**To:** Andrew MacNichol , Community Development Director  
**From:** Ryan A. Percival, P.E., Town Engineer  
**CC:** Mary Benedetto, Senior Planner  
**Date:** July 6, 2023  
**Re:** Grandview Road Extension

**PLAN SET:**  
MAJOR SITE PLAN MODIFICATION  
GRANDVIEW ROAD SUBDIVISION - PRIVATE WAY  
(GRANDVIEW ROAD EXTENSION)

We have reviewed the comments provided by the CPDC and Engineering Division in regards to the the Major Modification of a Definitive Subdivision known as Grandview Road. Comments and associated responses by Fodera Engineering (FE) follows:

PROJECT LOCATION:  
LOTS 2, 3, & 4  
GRANDVIEW ROAD  
READING, MA 01867  
PARCEL ID:  
MAP 27, LOT 404

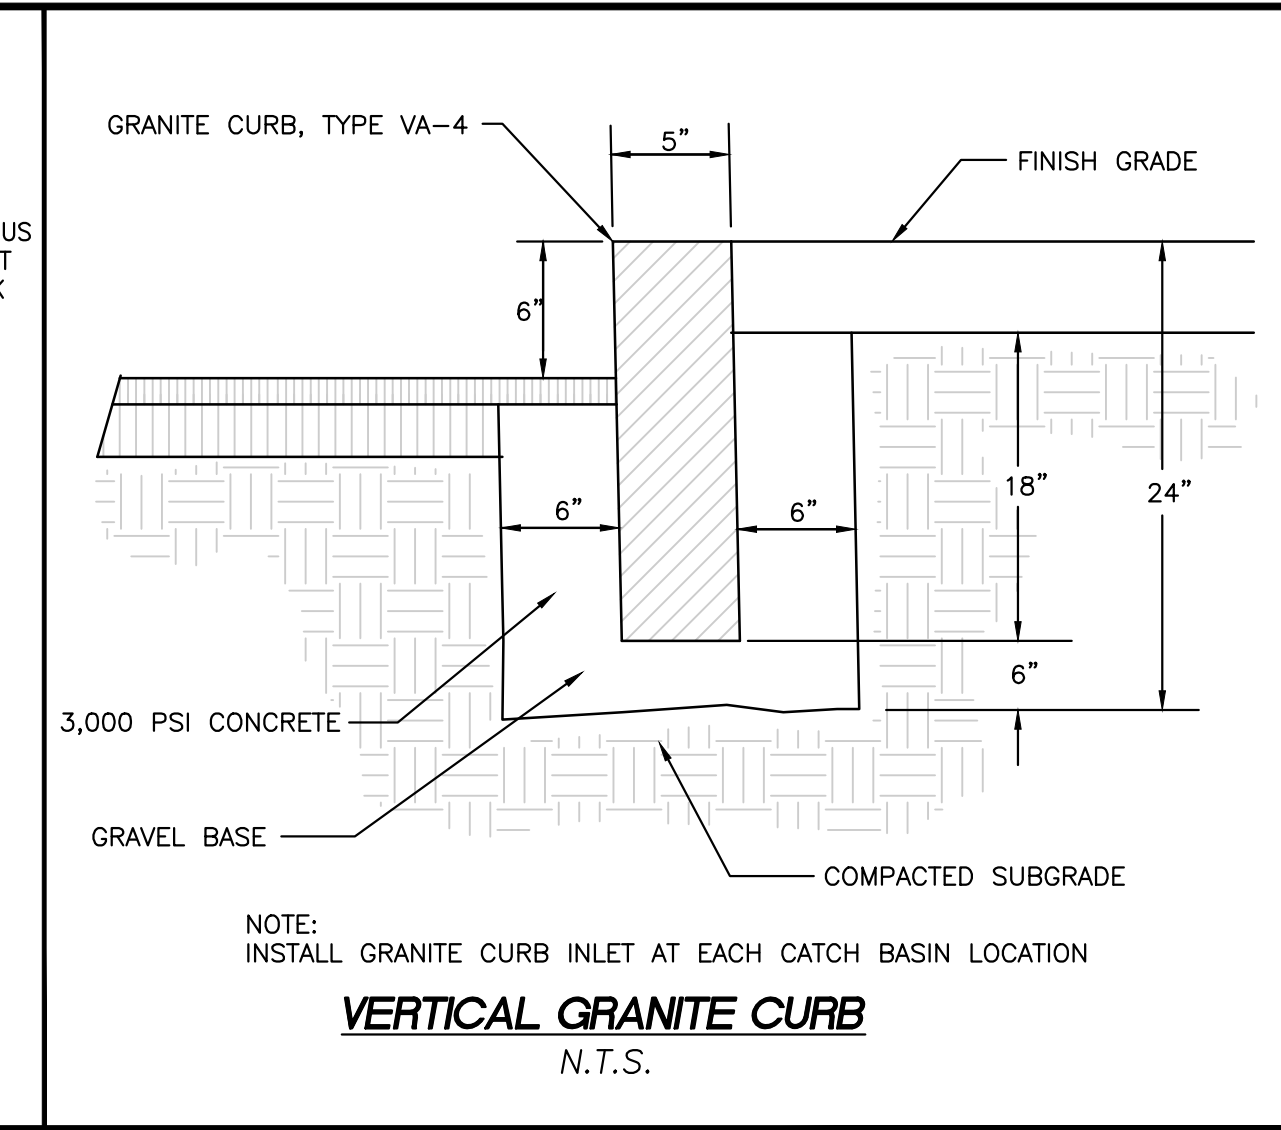
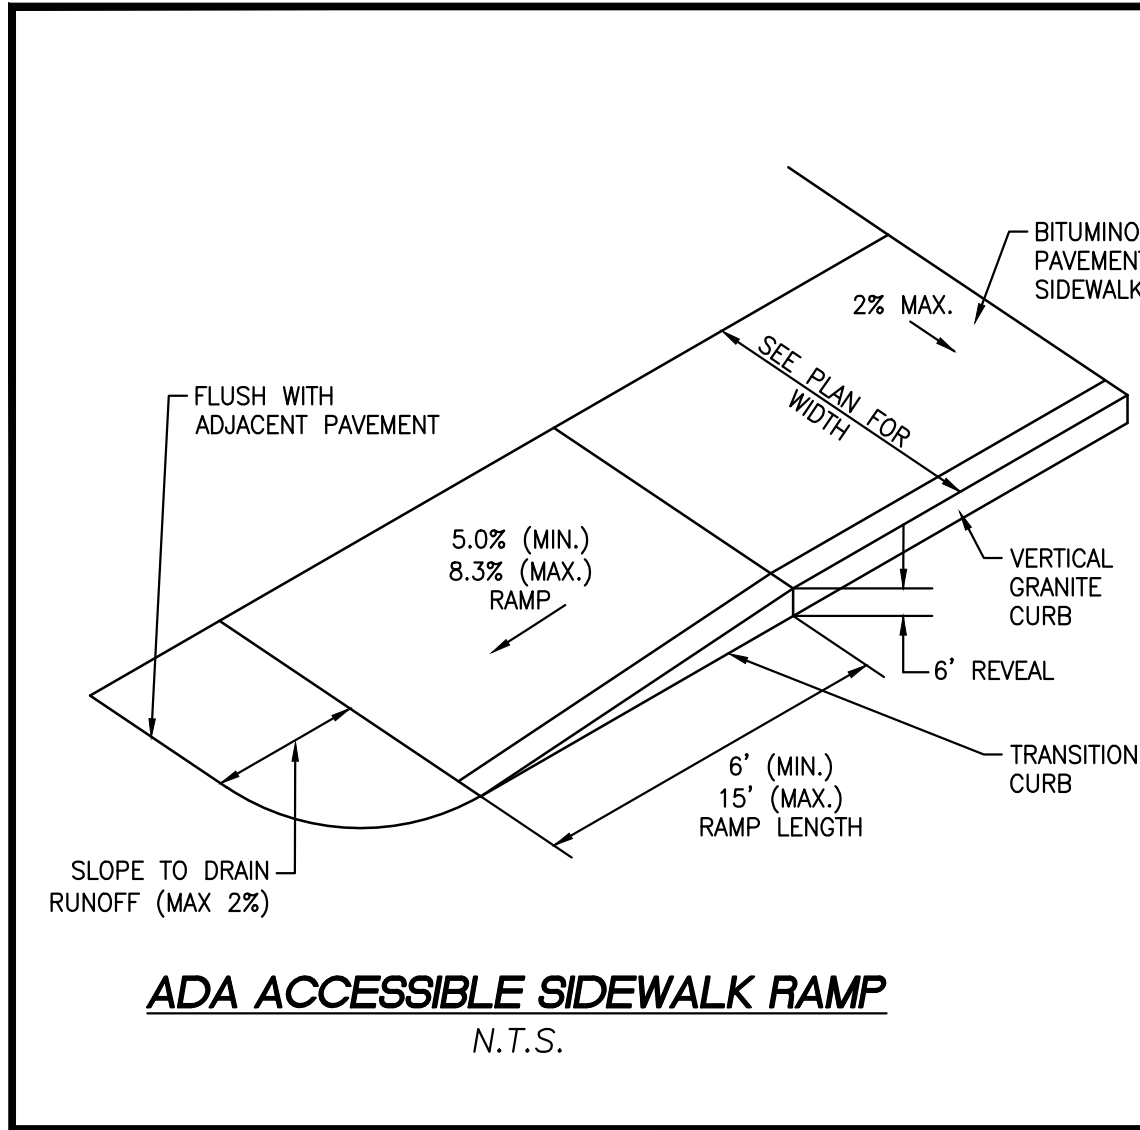
***FE Response: We limited crossings of utilities but it is inevitable that crossings will occur. There is a “Water Main Crossing” detail on sheet C-6.***
